COMPETITIVE ENGINEERING DEPARTMENT

RXL BULLETIN NO. 1 (1977/78)

INFORMATION AND CHANGES RESULTING FROM ALASKA TEST TRIP AND RXL SEMINARS:

RXL

Weight Identification -- See Figure:

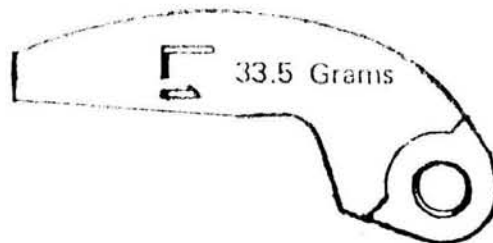
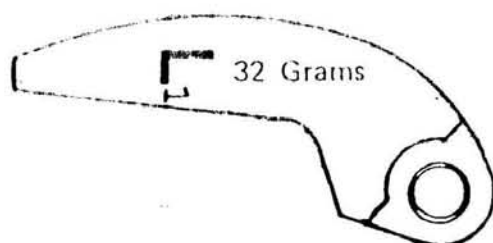
PROBLEM:

Low Engine RPM

High Engine RPM

Try next heavier blue clutch spring, part no. 7041080. If engine RPM needs to be raised more, install lighter clutch wts. 32 grams, part no. 5630188.

Try lighter orange clutch spring, part no. 7041060. If engine RPM needs to be lowered more, install next heavier clutch weight.

TETHER SWITCH RELOCATION:

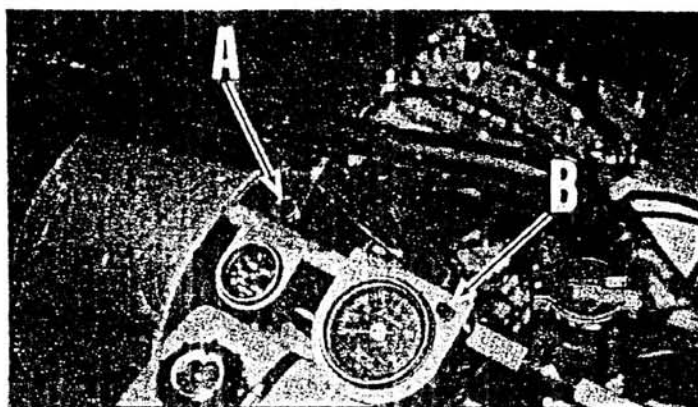
Refer to the photo below showing the relocation of the tether switch from the handlebar location (A) to the tachometer location (B). Measure 1/2" down from the inside radius of the tachometer mount and 1/2" in from the right side; see photo. At this point drill a 1/2" hole for the new tether location.

REAR CLOSE-OFF PANEL (INCLUDED IN RXL ENGINE KIT)

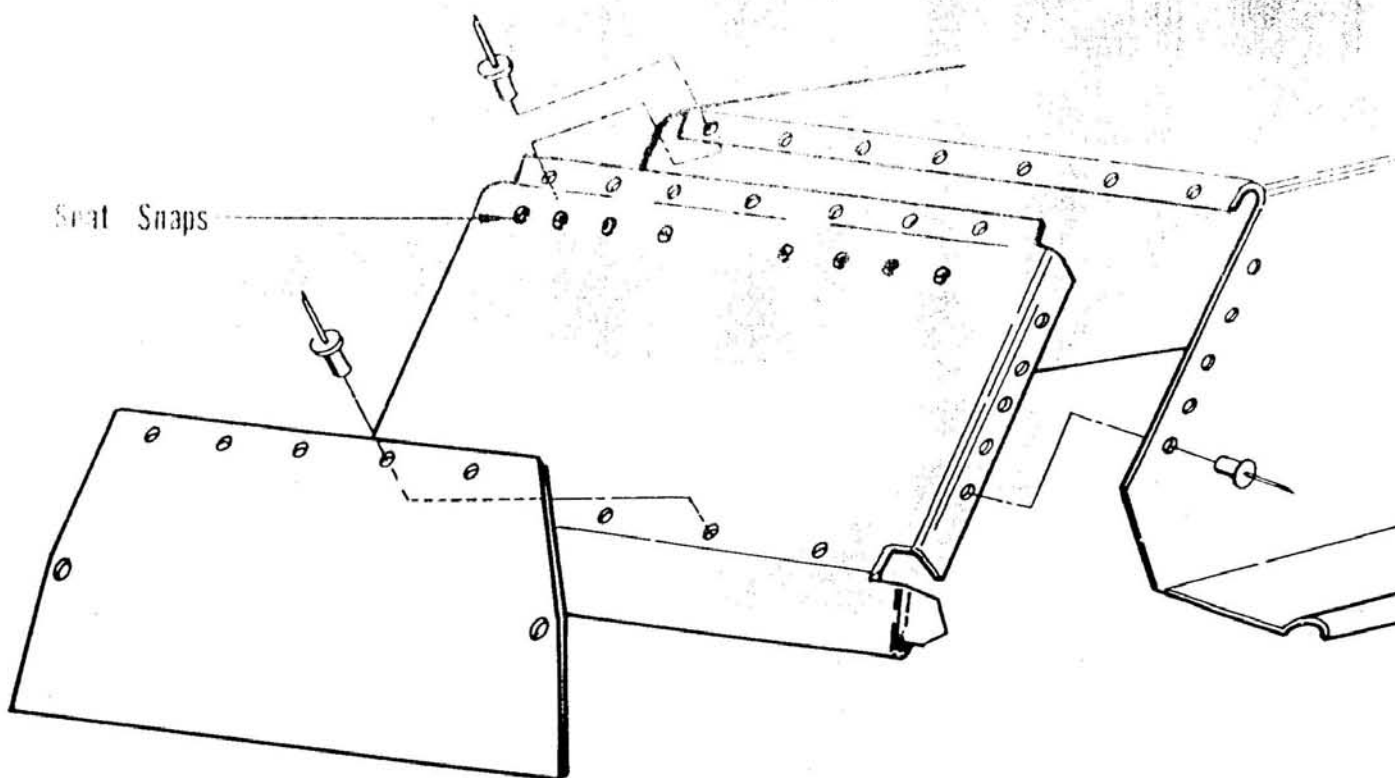
As a replacement part, Polaris has made available part number 5223877.

Procedure: Remove present close-off panel and snow flap by drilling out existing pop rivets. Install the replacement close-off panel using the top tunnel rivet holes as a line-up reference (see illustration). Secure with rivets on the top of the tunnel first. Next, drill the side panels with 5/32" drill size. Secure with 5/32 x 1/2" rivets. Fasten the snow flap to the close-off panel using 3/16 x 1/2" rivets. Relocate seat snaps and secure with rivets.
